Access Compliance Report

Public Rights-of-Way

(Pedestrian Signals)

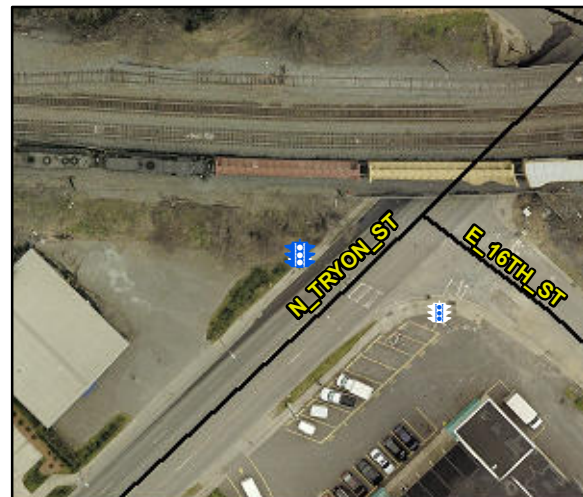
Surveyor Notes: TEXT HT 7/16

PROW/ADA: R410.6, TMUTCD 4e.08, R404.1, R404.7.3

Possible Solutions: Replace Signal Push Button With APS Button on New Post. Remove & Replace Sign.
